Office Action Summary	Application No. 10/702,505	Applicant(s) KWON, HAE WOOK	
	Examiner Toan C. To	Art Unit 3616

DETAILED ACTION

FIG. 3(Prior Art)

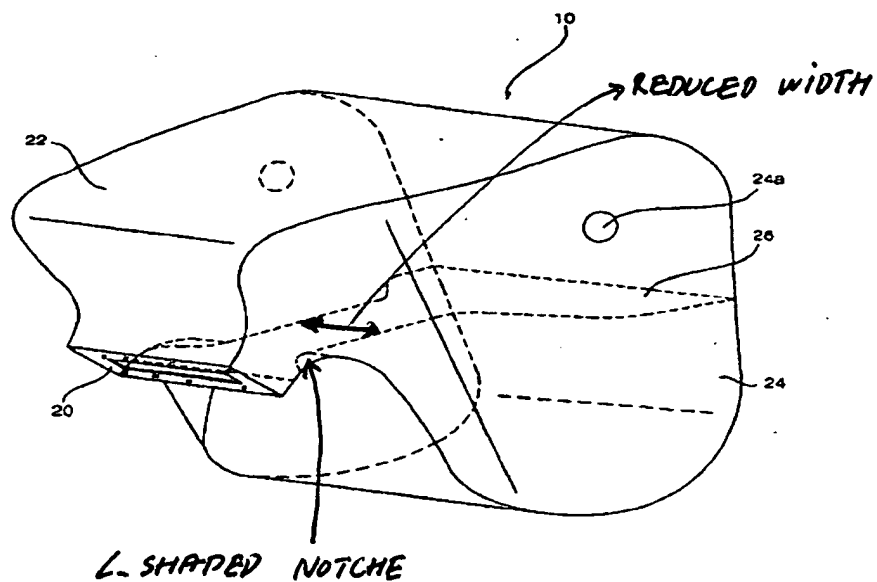
5. Claims 1-10 are rejected under 35 U.S.C. 102(b) as being anticipated by Prior art figures 1-4 of the instant application.

Prior art figures 1-4 disclose a cushion for an air bag system, the air bag system including a cushion expanded to the front of a passenger by means of gas discharged from an inflator when a collision of the vehicle occurs for absorbing shock transmitted to the passenger, wherein the cushion comprises: a main panel (22) having an inlet part (20) formed at one side thereof for allowing the gas discharged from the inflator to be introduced into the cushion therethrough; side panels (24) attached to both open sides of the main panel by means of sewing, respectively; and a tether (26) having one end fixed to the inlet part (20) of the main panel (22) by means of sewing and the other end fixed to the inner side of the panel opposite to the inlet part of the main panel while not

intersecting with the parts where the main panel and the side panels (24) are sewn; wherein one end of the tether (26) is fixed to the main panel (22) so that the tether (26) forms the inlet part together with the main panel (page 5, lines 15-17 of the instant specification); wherein the tether (26) is sewn to a first sewing part (28) sewing the main panel (22) and the side panels (24) at both sides of one end thereof, and wherein a second sewing part (30) sewing the end of the tether to the main panel is formed such that the first and second sewing parts intersect each other (A); wherein the tether (26) has notches formed at both sides of one end thereof where the second sewing part (30) is formed; wherein the notches are formed at both sides of one end of the tether with steps such that the width of the tether is reduced; wherein the end of the tether is disposed between the parts where the first and second sewing parts intersect each other; wherein the notches are formed with L-shaped steps; wherein the stepped parts are rounded; wherein the tether has wing parts formed at both sides of one end of the tether such that the wing parts cover the first sewing part 58 at the inlet part (see prior art figures 3-4 below for examiner's interpretation).
